City of Issaquah
Development Services Department
Administrative Site Development Permit

NOTICE OF DECISION

SUBJECT: Administrative Site Development Permit for Block 19 of the Issaquah Highlands

FILE NO.: ASDP17-00004

2 NORTH BICYCLE PARKING
1/4" = 1'-0"

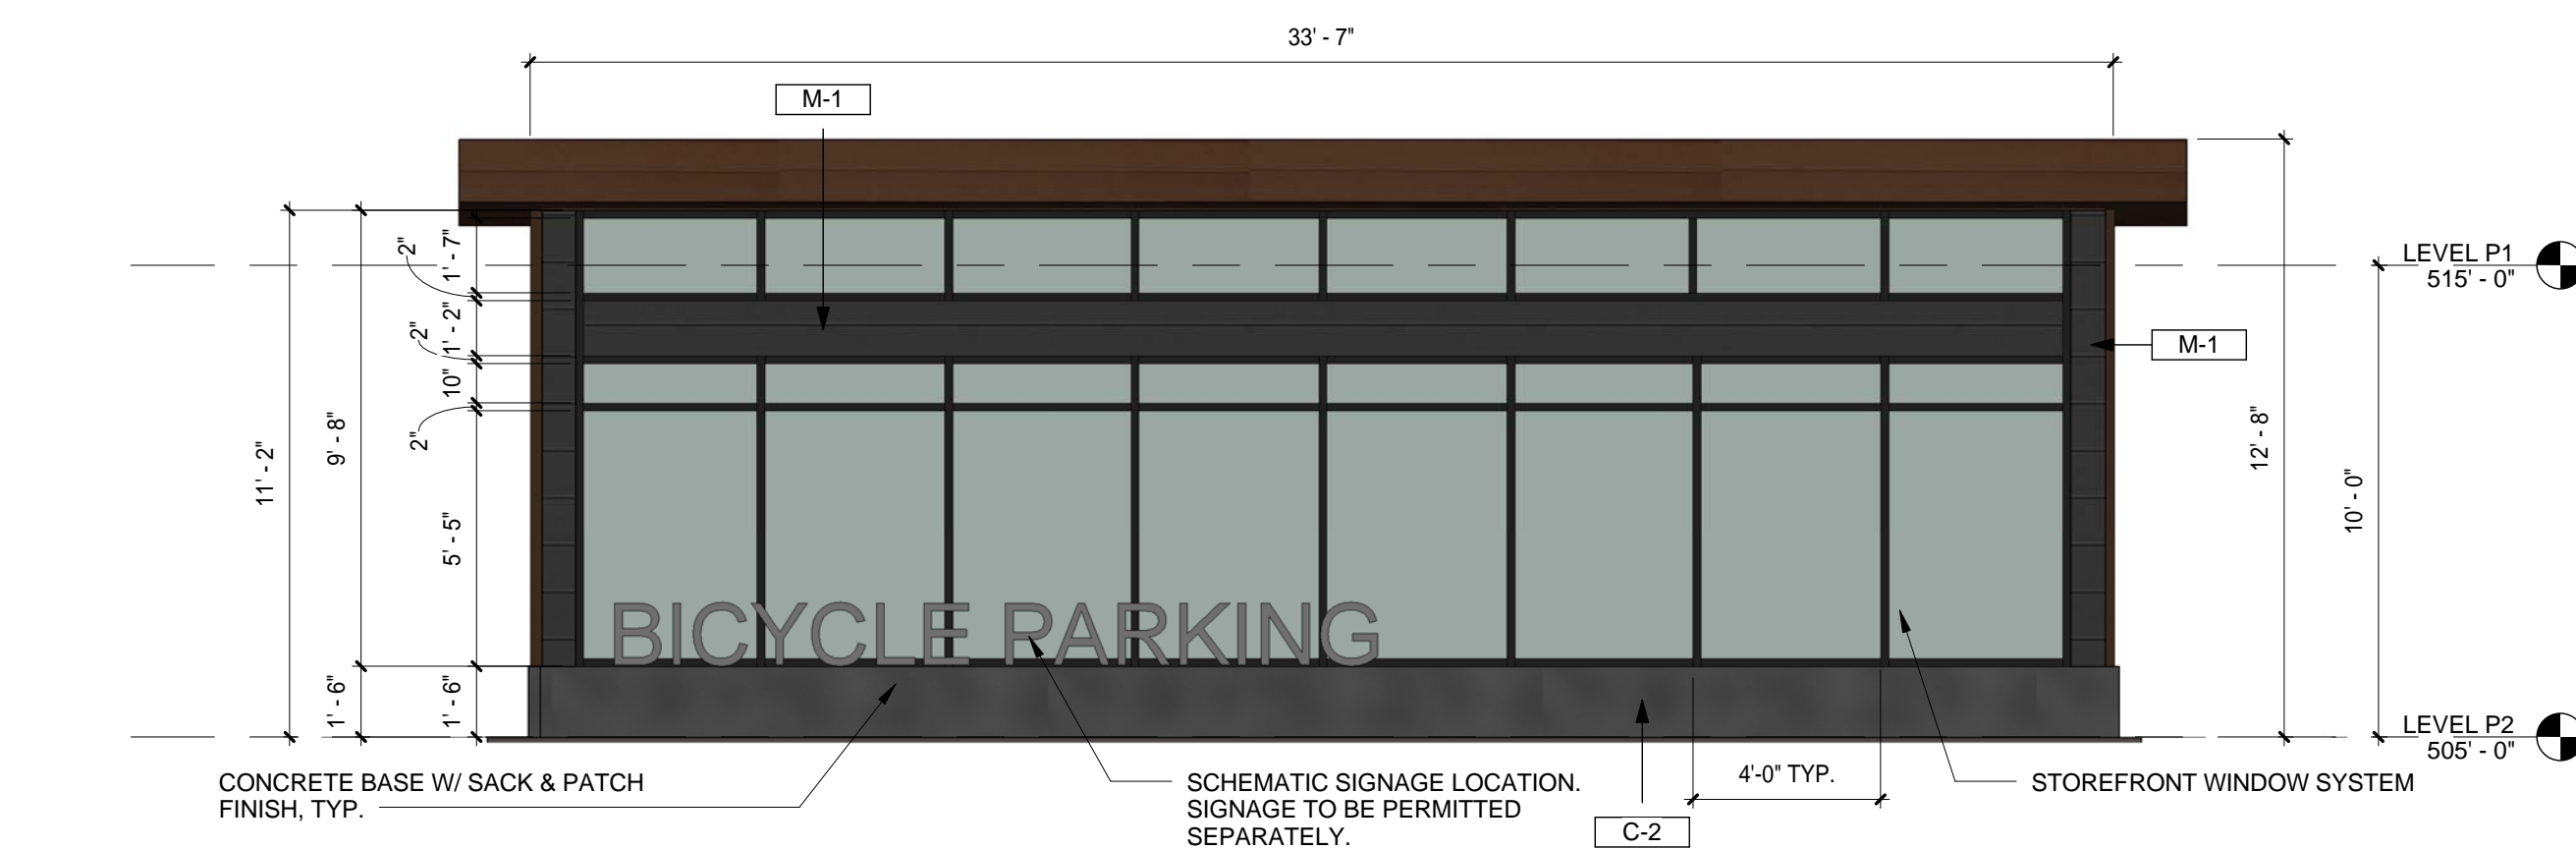
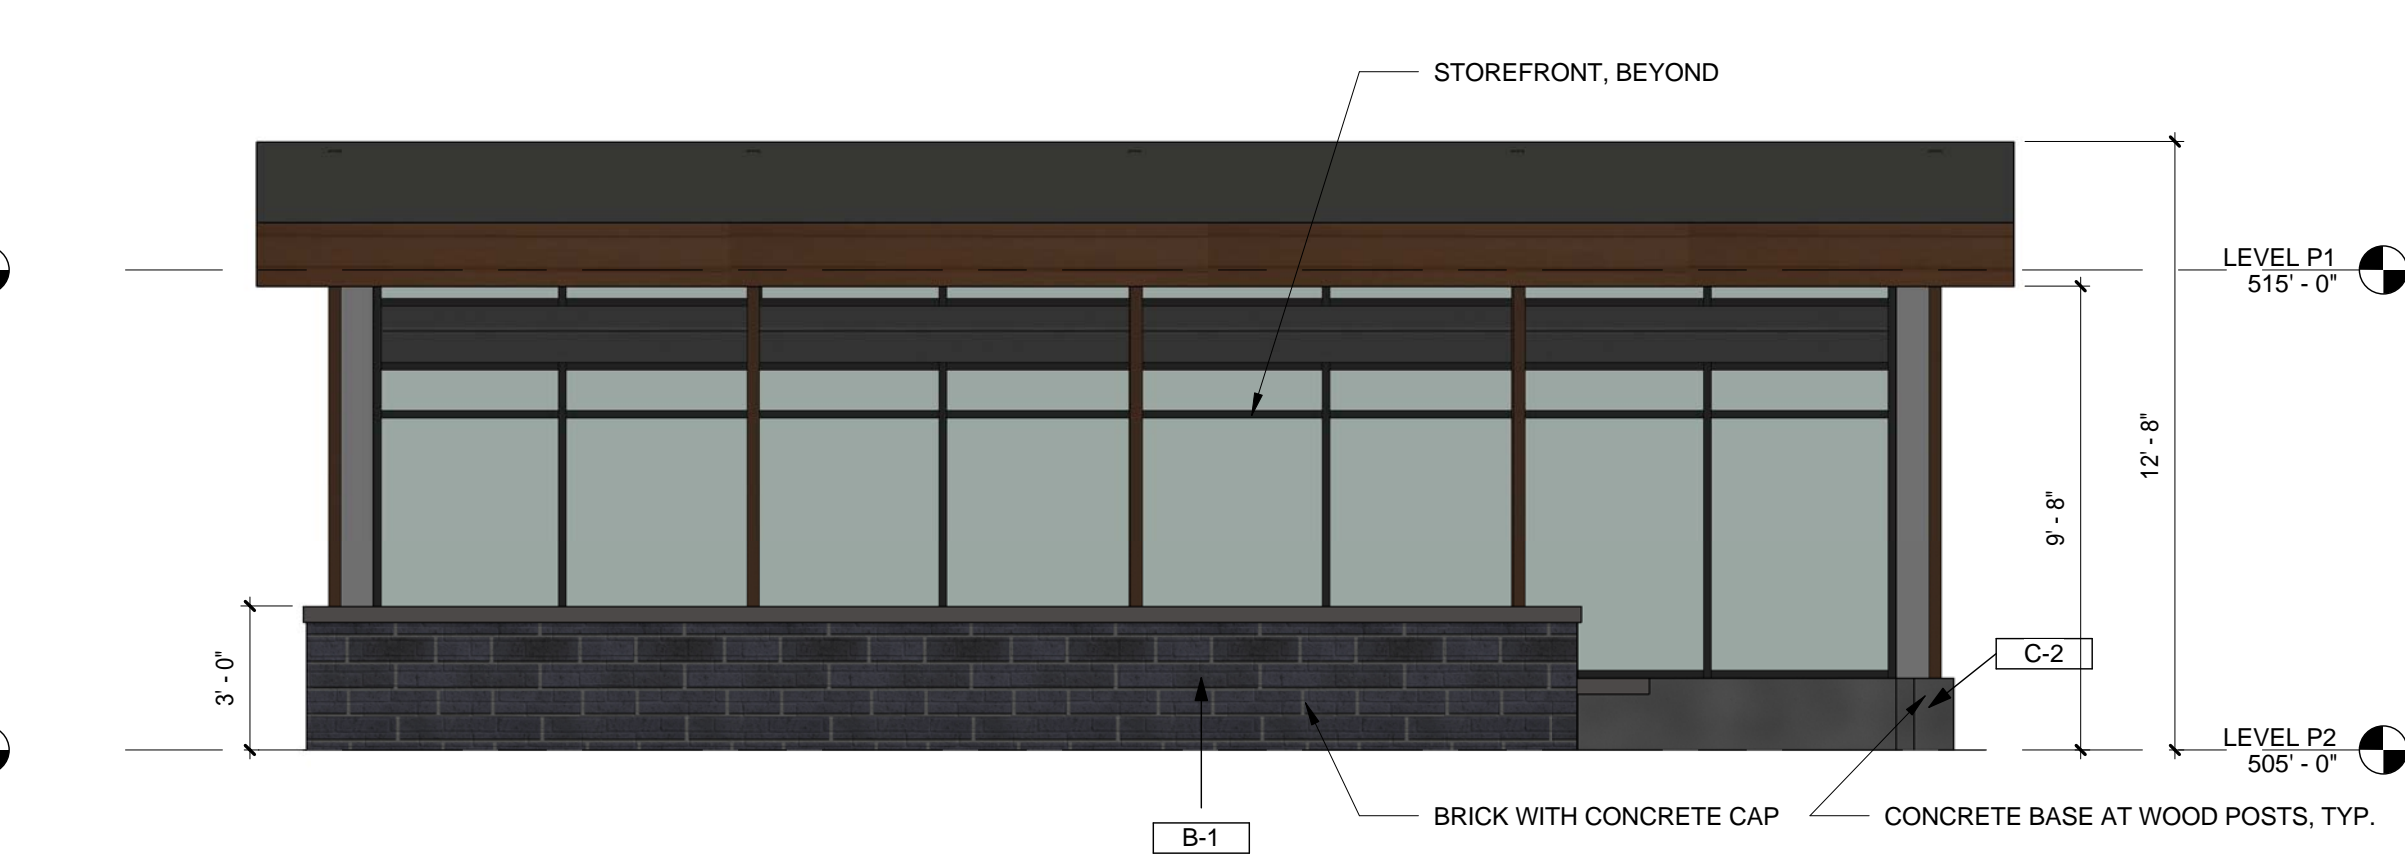
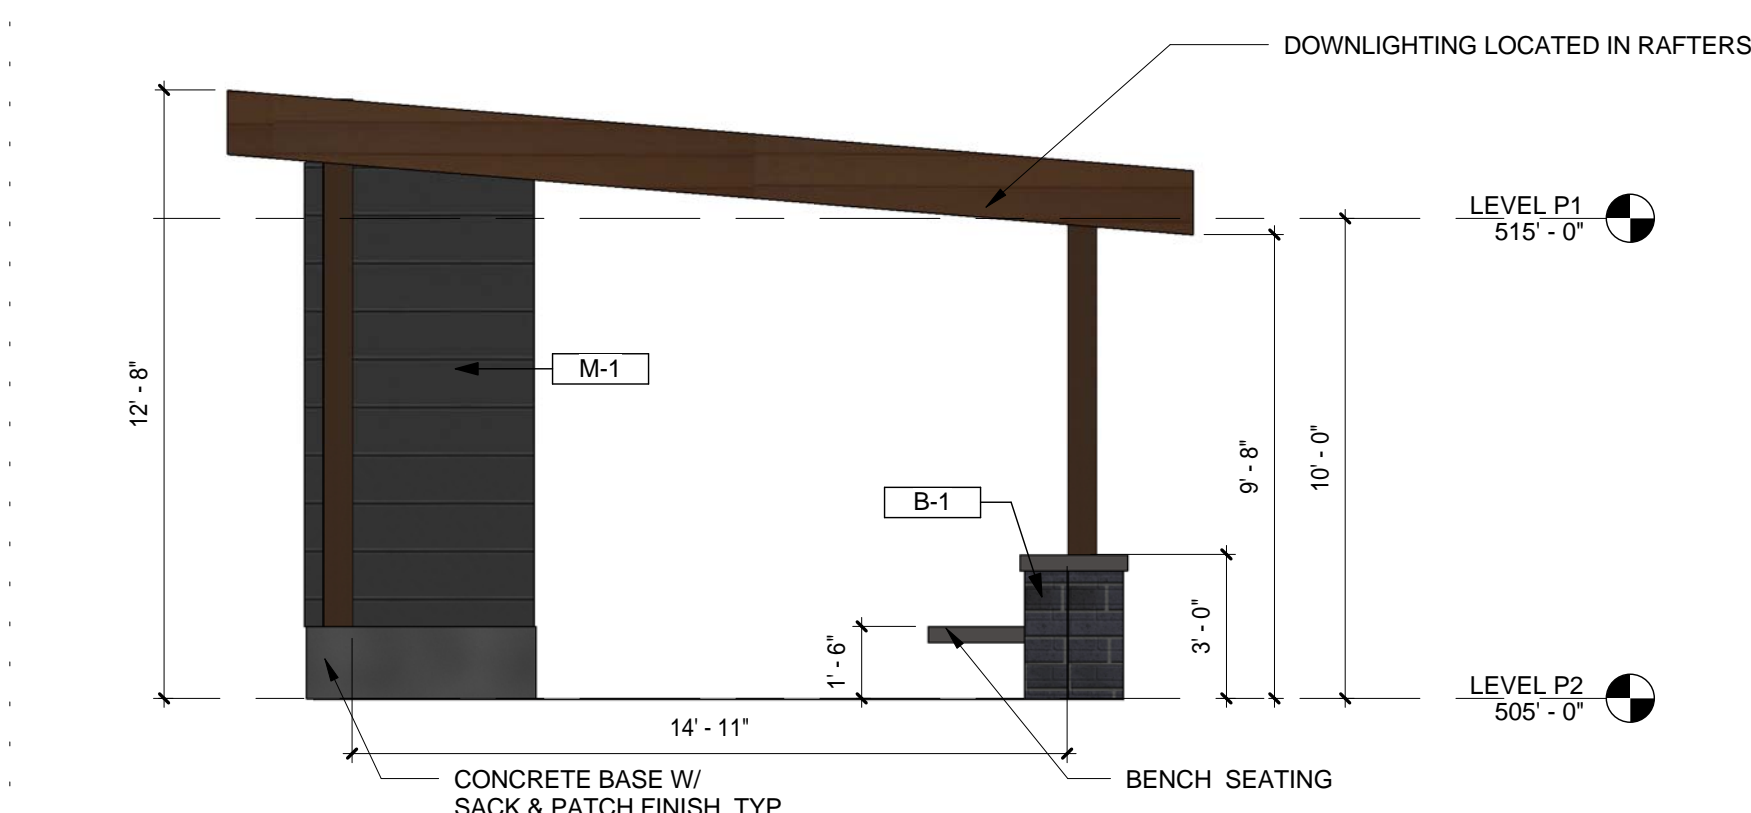
19. Bicycle parking is provided in the covered structure at the northwest corner of the site and in a bicycle storage room on level P1 in the main building. Verification that the number of bicycle parking spaces provided will comply with the code required minimum based upon the total number of vehicular parking stalls will occur with review of the Site Work and Building Permits.

Bicycles: The proposed plans show bicycle parking being provided in the covered structure at the northwest corner of the site as well as a bicycle storage room on level P1, but does not specify the number of bicycle parking spaces provided at these locations. For every 12 required vehicular parking spaces, there must be one bicycle parking space. Based on the requirement for 233 vehicular parking spaces, a minimum of 20 bicycle parking spaces would be required. Bicycle parking spaces should serve the residents, residential guests, and on-site employees. Additionally, bicycle parking in the covered structure should be available for use by the general public. Placement of the bicycle racks shall not impinge on adjacent uses such as walkways, entrances, etc., when the racks are fully used. The proposed bicycle parking locations would encourage their use, and the bicycle storage room would allow for a secured, weather-protected area for long-term bicycle parking.

6 SOUTH GENERATOR SCREENING
1/4" = 1'-0"

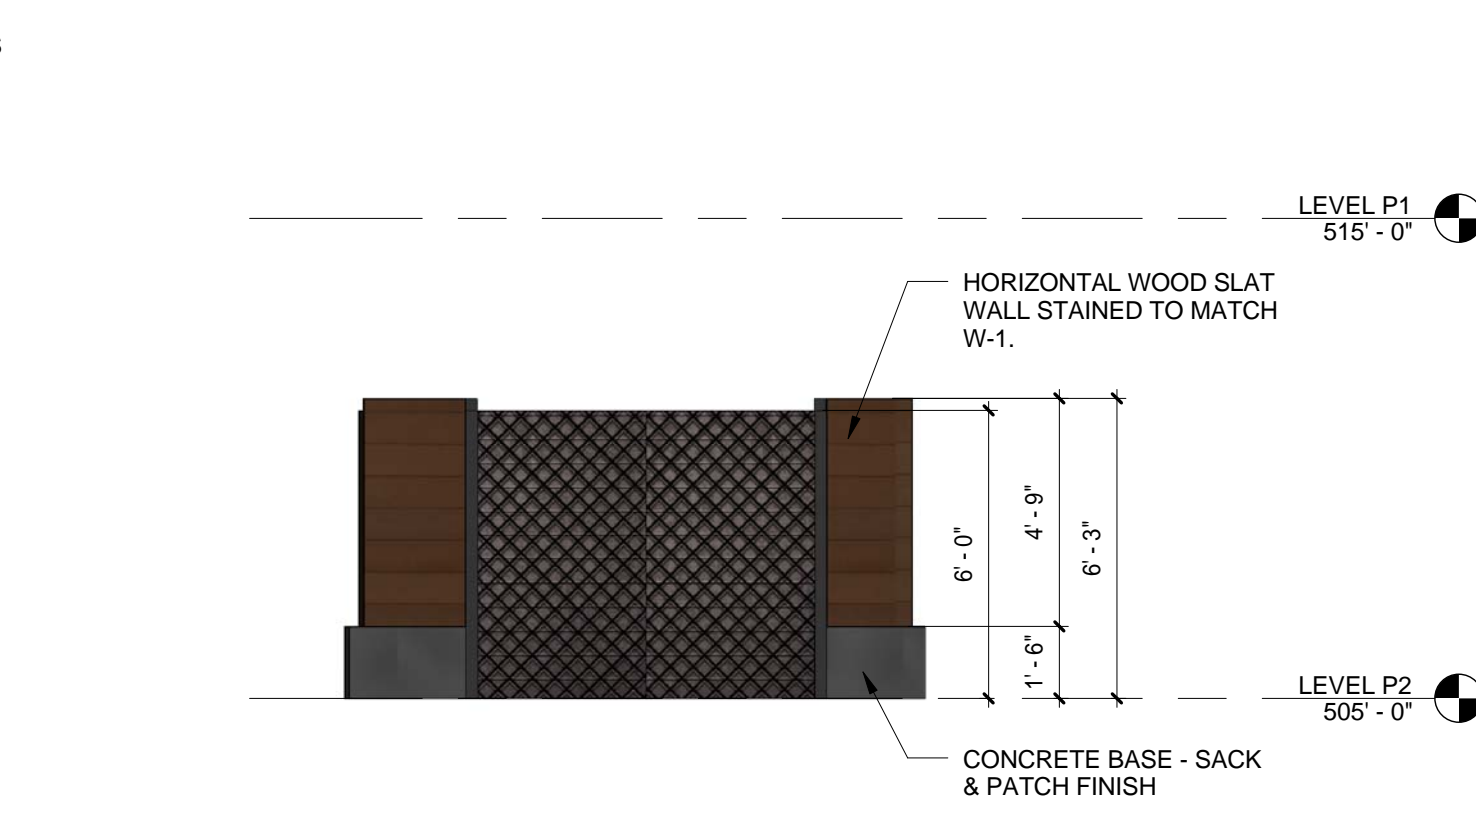
11. The generator shall be fully screened from view, including views from above. The screening material shall not be wood and shall not be visually permeable.

9. A generator with horizontal wood slat enclosure on a concrete base and what appears to be chain link gates is proposed at the northwest corner of the site. As with all mechanical equipment, the enclosure will need to be fully screened from view, including sufficient height to screen from views from above. The proposed generator must use non-diesel fuel, and noise attenuation may be required to comply with the City's noise standards. As the proposed wood slat enclosure may not provide sufficient noise attenuation and the chain link gates would not fully screen the generator unit, these materials would not be appropriate for the enclosure.
